<b>Docket Number:</b>	15-AFC-01
<b>Project Title:</b>	Puente Power Project
<b>TN #:</b>	215427
<b>Document Title:</b>	Testimony of Dr. Revell
<b>Description:</b>	Memorandum - Testimony on the Proposed Puente Power Plant
<b>Filer:</b>	PATRICIA LARKIN
<b>Organization:</b>	SHUTE, MIHALY & WEINBERGER LLP
<b>Submitter Role:</b>	Intervenor Representative
<b>Submission Date:</b>	1/18/2017 2:11:39 PM
<b>Docketed Date:</b>	1/18/2017

## **MEMORANDUM**

**Subject:** Testimony on the Proposed Puente Power Plant

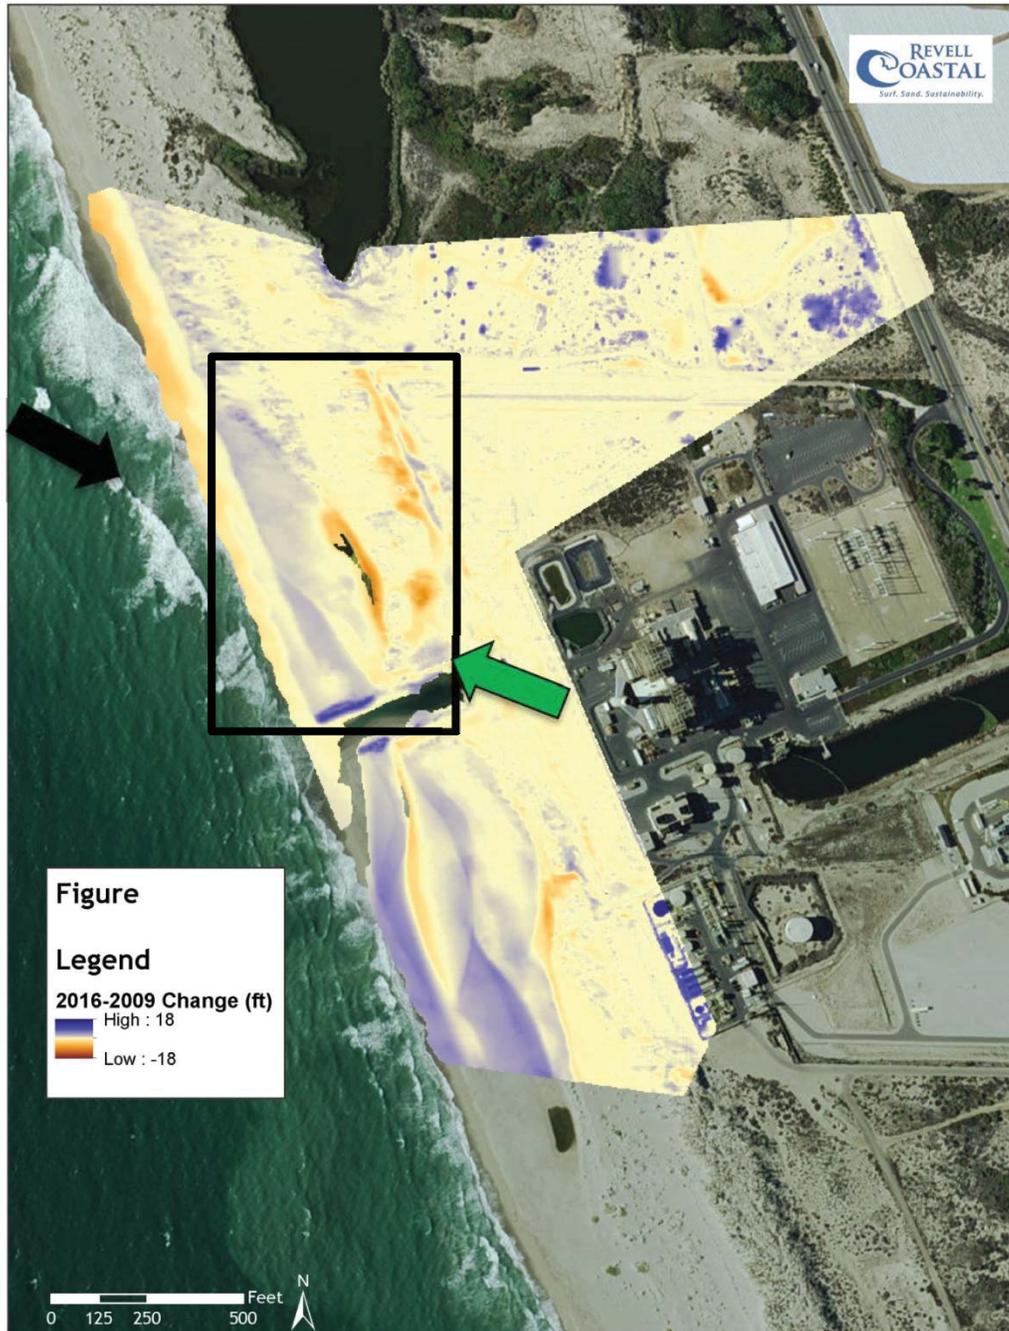
The most notable changes in topography occur at the dunes directly in front of the proposed location. These dunes were heavily impacted by recent storms—most likely during the energetic El Niño of 2015/2016 and possibly during the December 11, 2015 storm event, which destroyed portions of the Ventura pier and caused extensive flood damages around Ventura and Oxnard. The area of maximum dune erosion resulted in the vertical erosion of 12 feet of sand and reduced the buffering capacity of the dunes fronting the proposed site. The beach during the more recent time periods (2009 and 2016) shows substantial erosion of the dunes at the back of the beach (Upper transect) in the area fronting the proposed site.

The mild accretion of the middle section of the beach is accompanied by erosion of in the lower (seaward) section of the beach.

The present beach condition has much less protective dunes fronting the proposed Puente Site than assumed in the 2009 data that was relied upon for the hazard modeling in the FSA.

Figure 5. Beach showing elevations and topography through time collected from just north of the

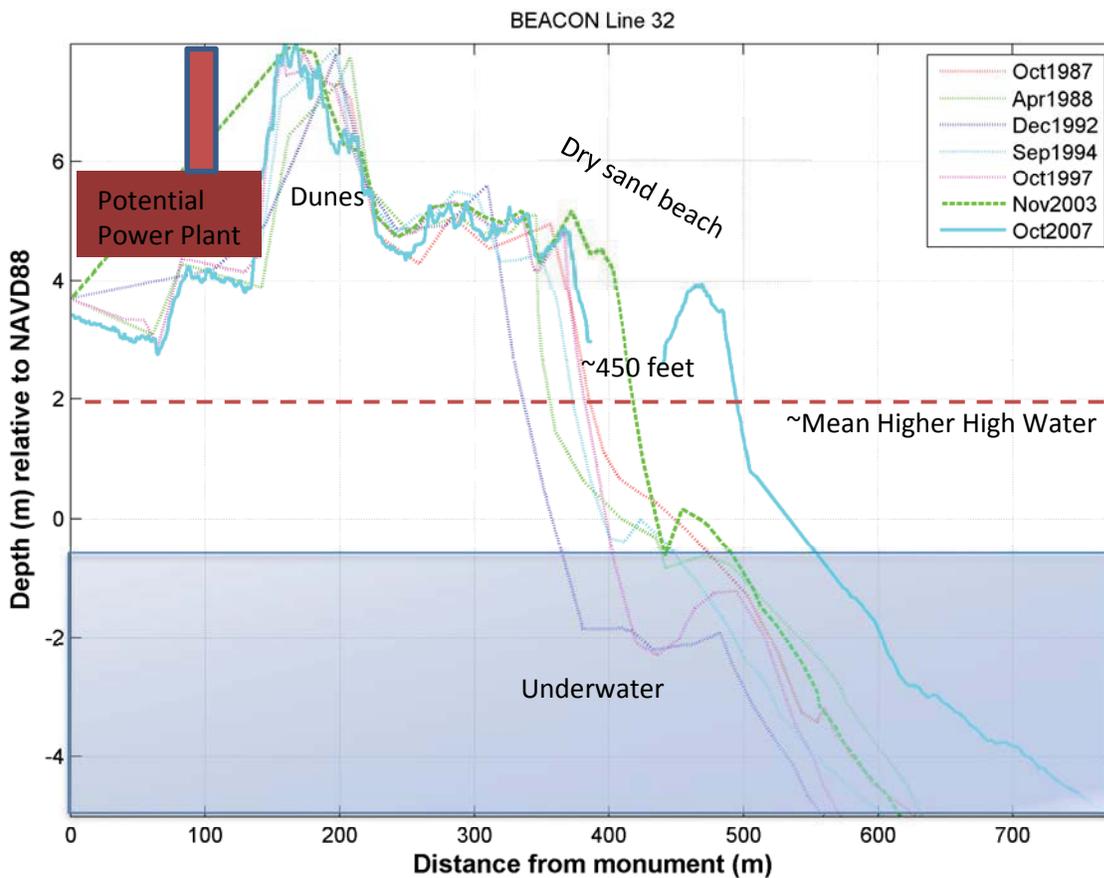
Since 1987, BEACON, a joint powers authority representing all of the communities in Santa Barbara and Ventura Counties which focuses on beach erosion issues, has collected beach profiles near the site episodically. More recently as part of a larger regional effort to understand short term seasonal and longer term dynamics, this work has been synthesized (Barnard et al 2009). As part of that research historic and recent beach profiles were collected and synthesized (unpublished data BEACON/USGS). Profile 32 is just north of the proposed site in front of McGrath Lake and show substantial variability, widening and narrowing through time as measured in beach width and beach slopes (Figure 5). The variability of these beach profiles around the approximate MHHW elevation (~2m) show about 450' feet (~150 meters) of changes through time in no particular sequence. While these changes include seasonal and episodic changes without specific causation it illustrates the variability of the beach at this single location near the site. The widest beach shown in October 2007, follows the major 2005-2006 flood event on the Santa Clara River and was reflected in the 2009 LIDAR data used for all of the coastal hazard mapping. This sand that has largely been trapped on the beaches in between front of the site due to the lack of sufficient dredging at the Channel Islands Harbor.

Figure 6. Topographic profiles showing the beach variability across the MGS site from October 1997, April 1998, November 2009, December 2016.

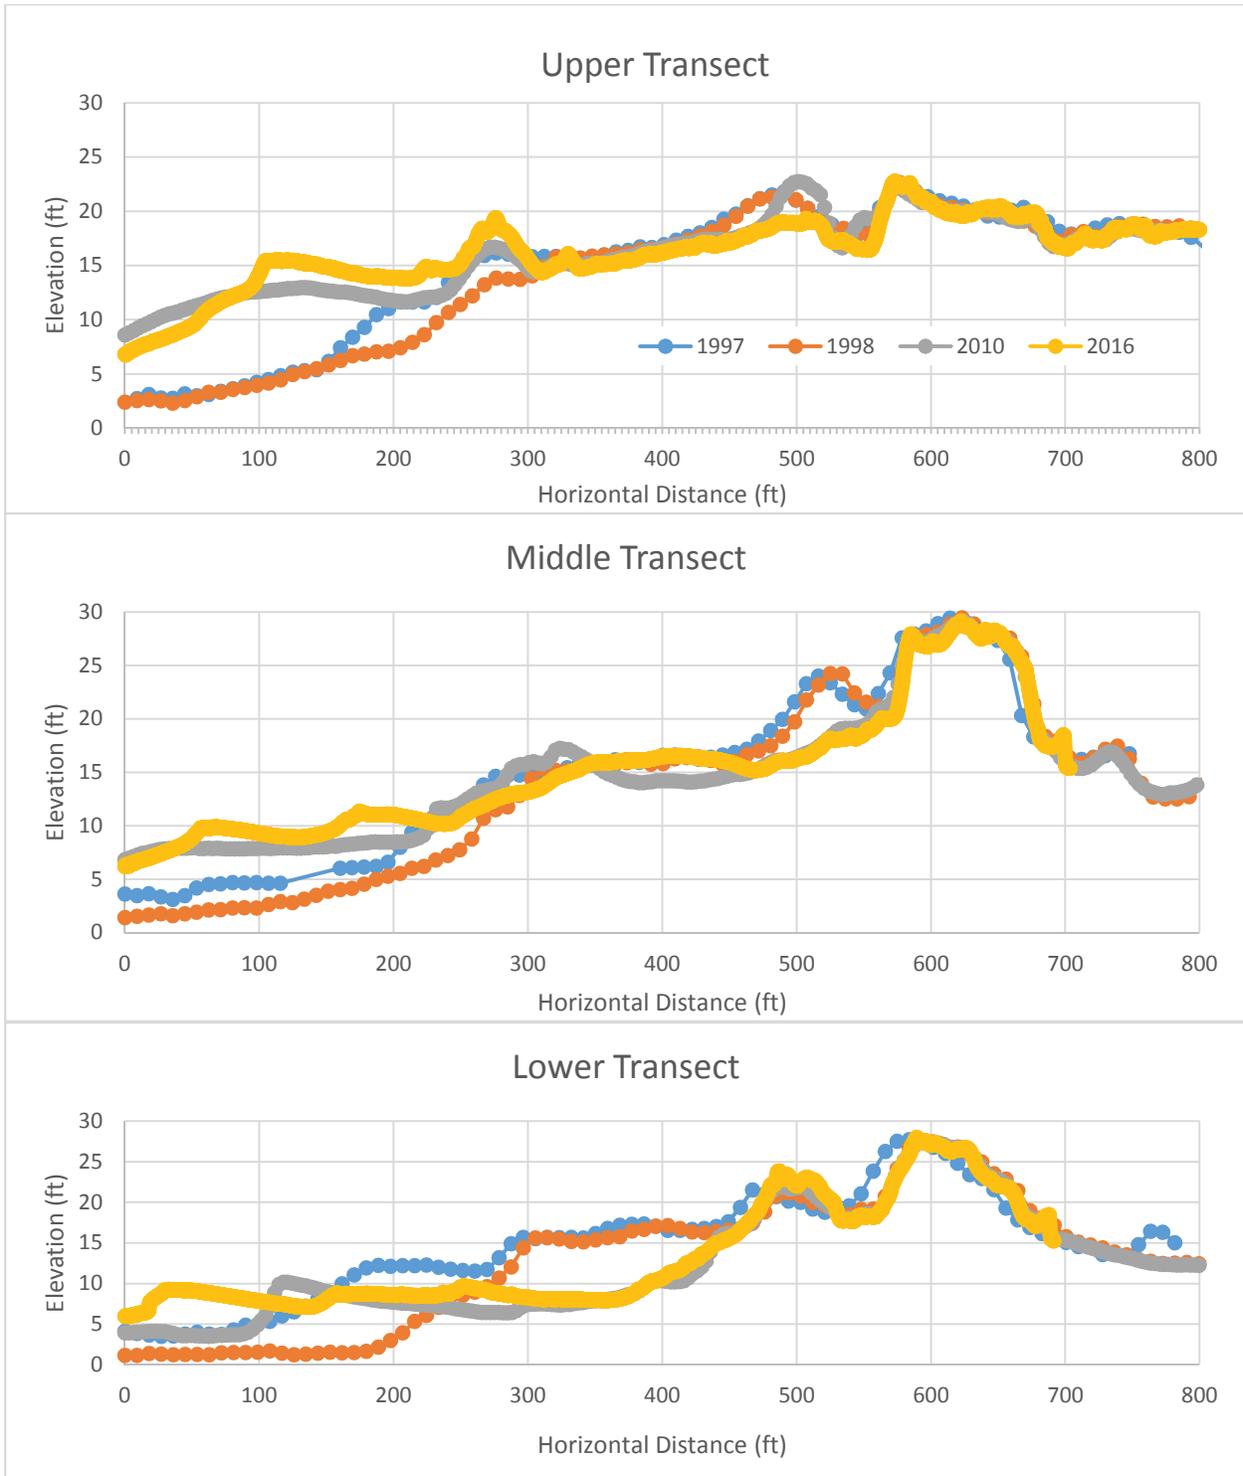
There are several general findings from the geomorphic analysis of the transects (Figure 6) which are summarized in Table 1.

In general, the beach during the 1997-98 time period was narrower by about 200 feet. The erosion during this El Niño only resulted in about 100 feet of shoreline change, likely as a result of the peak wave heights occurring during low tide. The earlier time period corresponds to a time of reduced dredge bypassing from the Ventura Harbor and below average coarse sediment discharge from the Santa Clara River (Note that while 1997-98 was a large discharge year, the sediment did not show up on the beach until after the topographic LIDAR survey was taken in April). The Lower transect shows up to 9 feet of vertical erosion along much of the beach, and about 7 feet of dune erosion (Middle Transect) (Figure 6 middle). The time period post 2009 which includes the two most recent profiles are indicative of increased sediment from high rain years in 2004 and 2005, normal dredging at Ventura Harbor and a very reduced dredging of Channel Islands Harbor which has completely filled the sand trap upcoast of that harbor and backed up sand along the coast in front of the proposed Puente site (see Sediment Supply discussion below). Please note this same time period has also resulted in substantial erosion downcoast at Hueneme Beach.

In summary, the geomorphic analysis demonstrates that the beaches and dunes of this site are quite variable and have widened and narrowed with slopes that steepen and flatten across the beach during the same time periods. This variability has and will always occur. This finding has implications for all of the coastal hazard mapping (FEMA, TNC, and COSMOS) which relied on the same 2009 topographic data set that was collected during a wide beach time. The 2009 elevation data shows one of the widest beach conditions documented in the historic record. The next section, specific to the individual coastal modeling, demonstrates the implications of the more recent topographic data (Figure 1) and the geomorphic variability (Table 1) on the calculations and mapping of existing and future coastal hazards.

Figure 8. Projections for 5 climate scenarios for mean annual sea-level rise 50th %tile (solid lines), bounded by the 95th and 5th %tile projections (shaded in same color as 50th %tile)

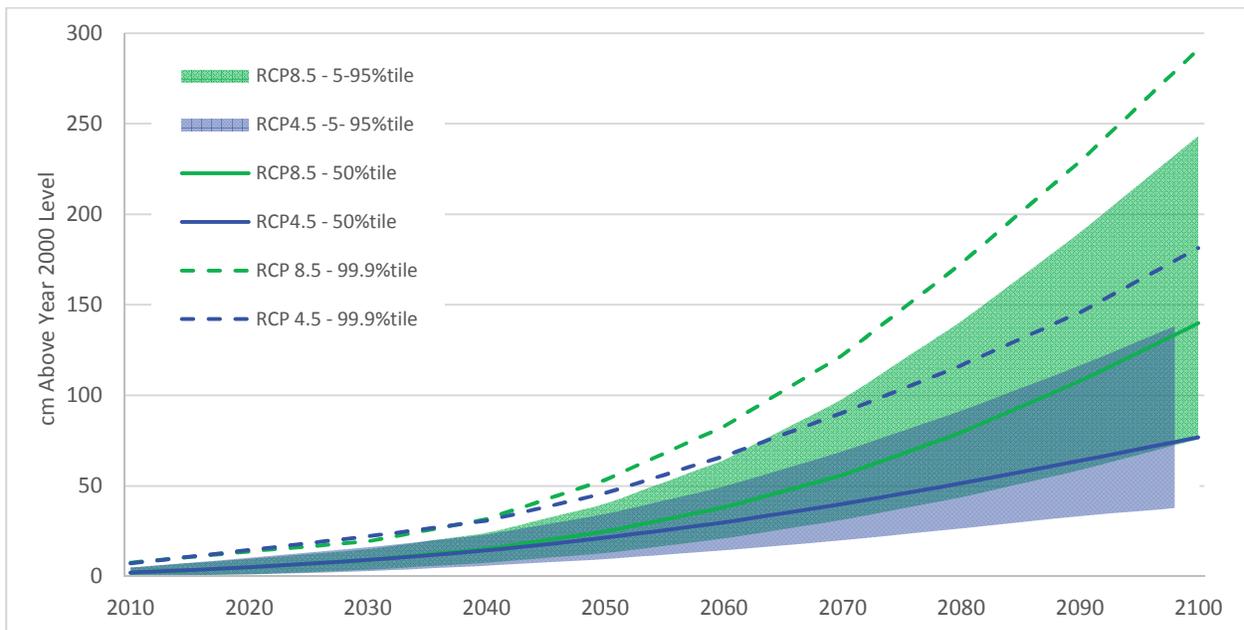
On October 10<sup>th</sup>, 2016, the Climate Action Team Research Working Group released the latest guidance for selecting sea level rise (SLR) scenarios for California’s 4<sup>th</sup> Climate Change Assessment.<sup>9</sup> This guidance, based on the same modeling efforts from Cayan et al., 2016, recommended using the RCP 8.5 50<sup>th</sup>, 95<sup>th</sup>, and 99.9<sup>th</sup> percentile projections for planning horizons before 2060, and RCP 4.5 and 8.5 (50<sup>th</sup>, 95<sup>th</sup>, and 99.9<sup>th</sup> percentile) beyond 2060.

This data and implications have not been included in the assessment of impacts to the proposed project and warrant additional discussion and consideration. The following sections discuss the effect of sea

Figure 9. FEMA results with revised topography, showing future VE zones with sea level rise.

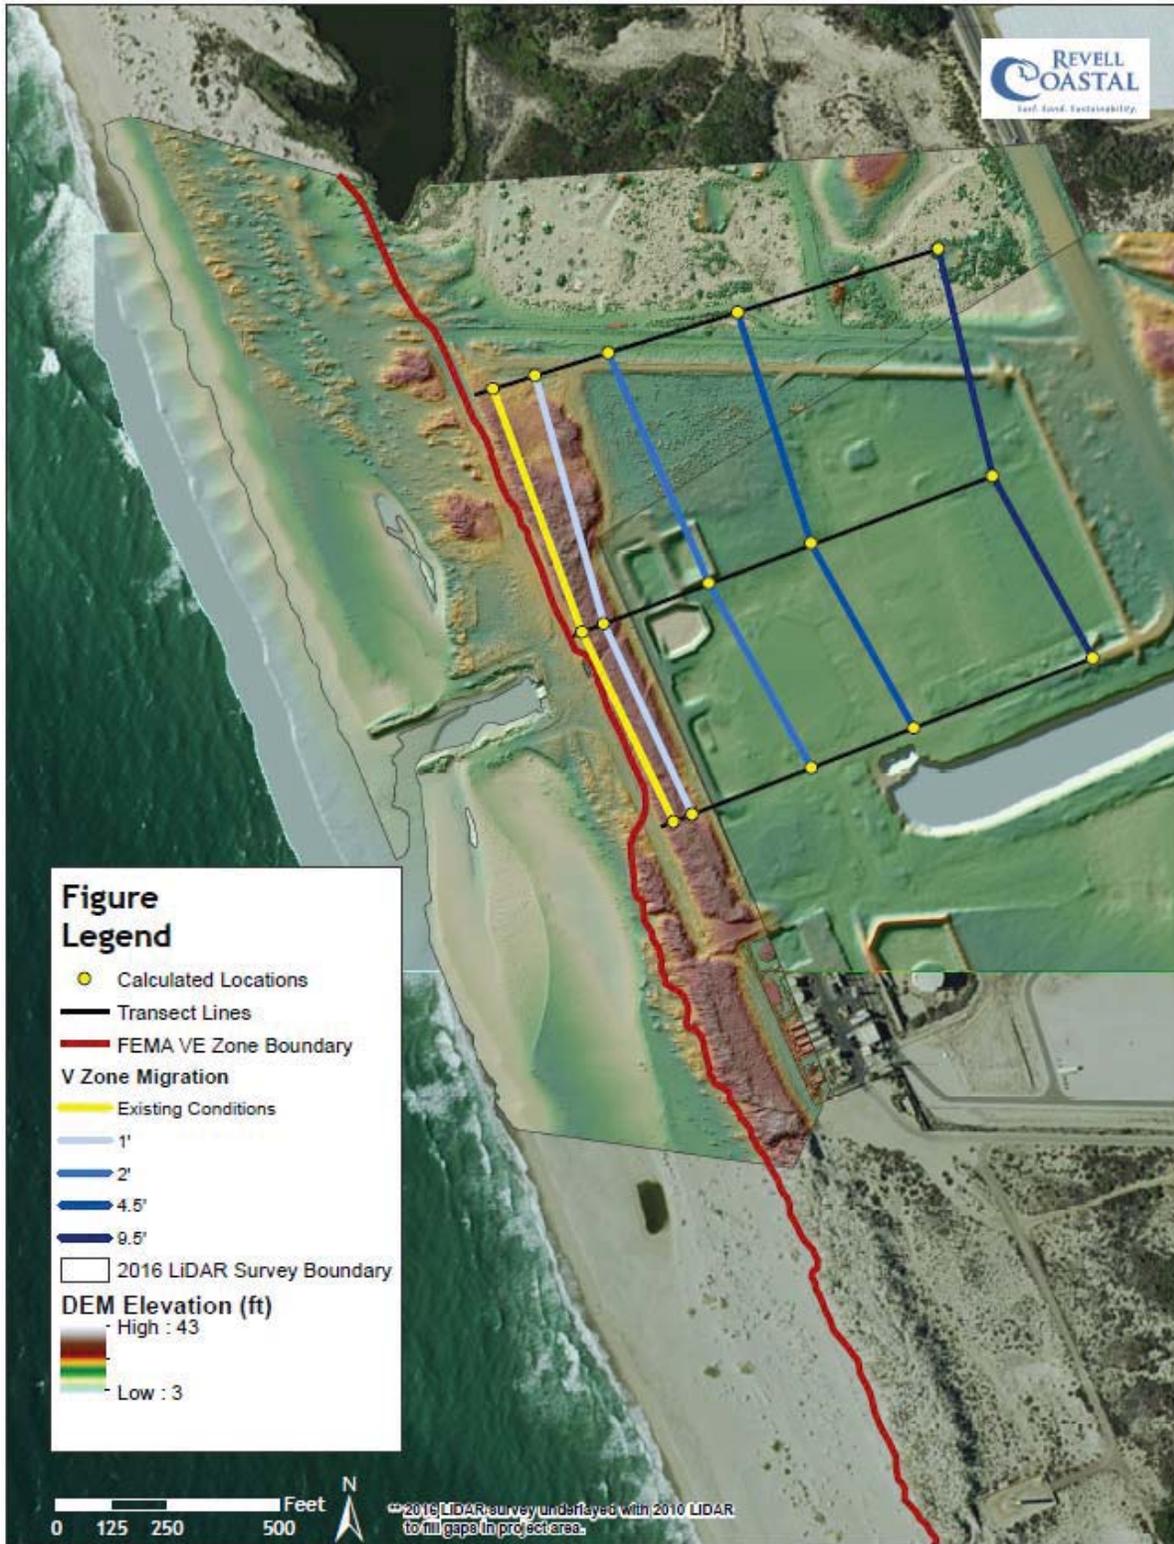
Following the methods laid out in this technical manual, I calculated the VE zone under current conditions (using the 2016 topographic data) and projected the Preliminary FEMA coastal hazard maps in the future, taking into account sea level rise assumptions for 2050 (1’ and 2’) and 2100 (4.5 and 9.5 feet).<sup>12</sup> (Table 3 and Figure 9). Results in Table 3 are shown for the Upper transect (which is the transect closest to the proposed site). Figure 9 shows the results of the Composite slope analysis on the 2016 topography for all transects.

The data show that the VE/Run-up zone intrudes well into the site during the lifetime of the project.

Figure 10. Flood damages to electric infrastructure during the 1969 Flood in Ventura County.

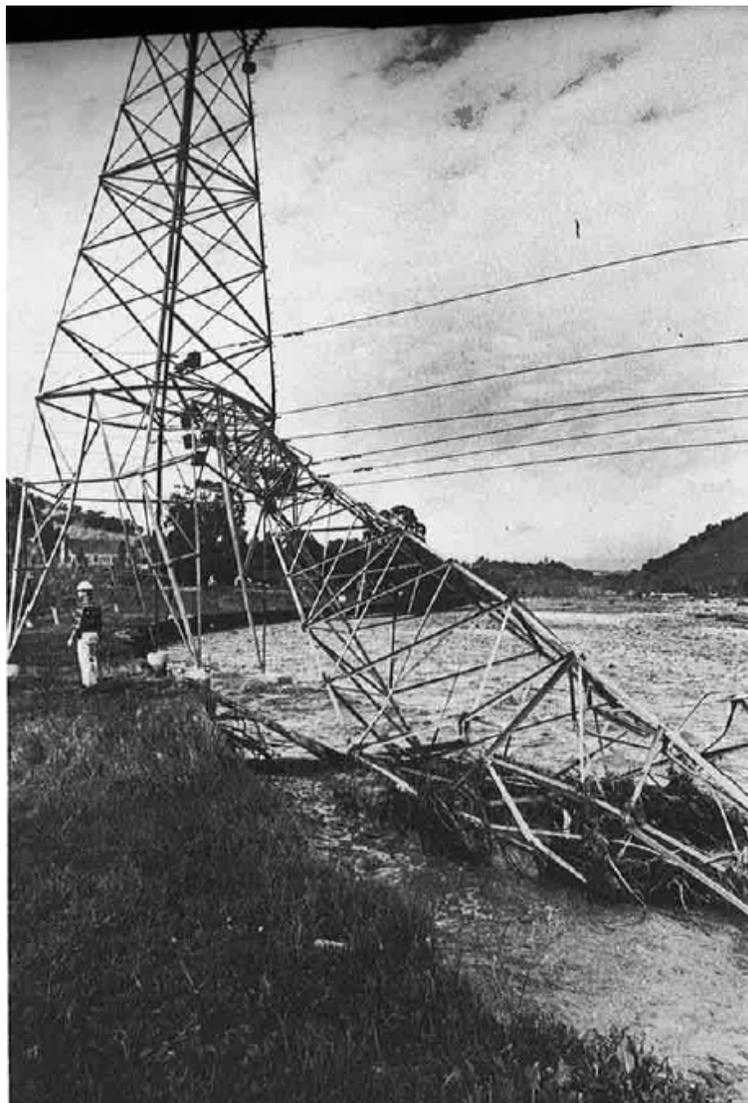
The FSA document relies on the FEMA FIRM map to determine flood potential to the site. It should be noted that the site previously was flooded during the 1969 flood resulting in the increase of an earthen levee along the northern boundary at an elevation of 18' NAVD. This flood event had regional impacts to the power grid (Figure 10.)

Figure 11. Tsunami inundation associated with an earthquake on the Pitas Point/Red Mountain Fault (Everest 2017).

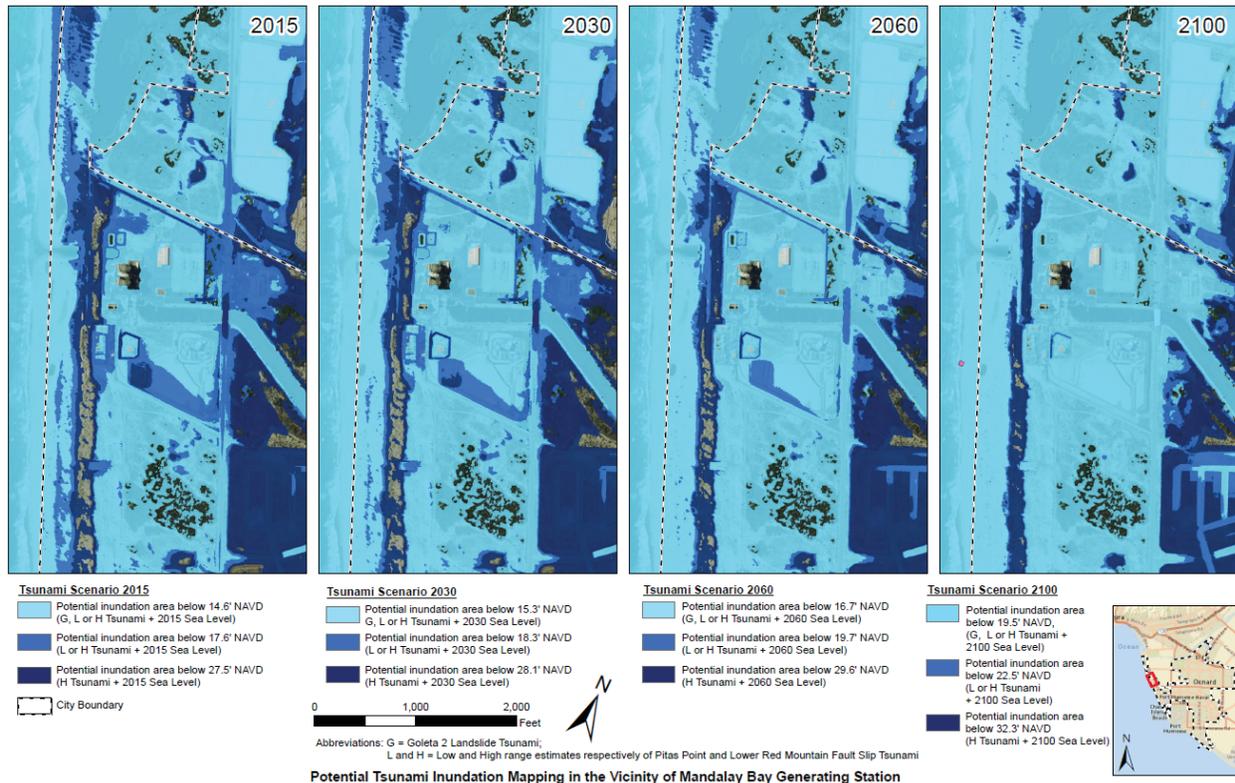
Recent research published in the Journal of Geophysical Research Letters by UC Riverside and U.S. Geological Survey scientists in 2015<sup>23</sup> provided new consideration for local tsunami inundation in the Ventura region (Figure 11). This information is NOT considered in the FSA. The study used a three-dimensional dynamic model to predict the tsunami associated with an earthquake and fault slip along the Pitas Point and Lower Red Mountain Faults offshore of Ventura. Based on the results of the scenario presented in the publication, the tsunami heights along the Oxnard coast were found to be in the range of approximately 13.1 to 23.0 feet leading to a tsunami inundation level of between 17.6 and 27.5 feet. If the high end of this tsunami run up elevation proved true, that would place the proposed Puente Site in a tsunami hazard zone today. If the worst case scenario of sea level was realized,<sup>24</sup> then the potential

tsunami run-up elevations could reach between 19.6 and 29.5 feet by 2050, and 27.1 and 37.0 feet by 2100 (Figure 11).<sup>25</sup>

An earthquake with an epicenter on the Red Mountain Fault could have multiple impacts to the proposed site. The first would be damages to the Puente site from the shaking, potentially causing liquefaction. From the FSA it is not clear what seismic shaking parameters were considered in the structural design. But the site is clearly in a liquefaction zone.<sup>26</sup> Second, the shaking could down transmission lines. The worst case scenario analyzed in the FSA included down transmission lines in one direction. In reality, transmission lines would likely be downed in all directions. If Puente is constructed, then the majority of local generation resources needed for recovery from a major earthquake event (Puente, McGrath, Mandalay 3) are all concentrated in the same small area that is highly vulnerable to a tsunami following that event -- threatening the long term reliability of the region.<sup>27</sup> This was not included in the FSA analysis. Third, the earthquake would likely generate a tsunami capable of reaching
